Southern Nevada Amendments to the 2024 International Fire Code

Including various NFPA Standards

SNFC / FPAN International Fire Code Committee

Version Dated: April 8, 2025

TYPE A PACKAGE

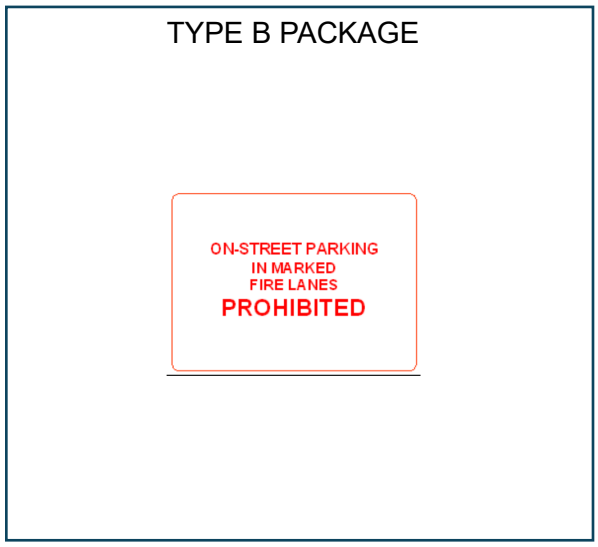
Signs shall be installed not less than 6 feet (1830 mm) and not more than 10 feet (3048 mm) from the ground level. Posts for signs shall be metal and securely mounted, unless written permission for alternatives is obtained prior to installation from the fire code official.
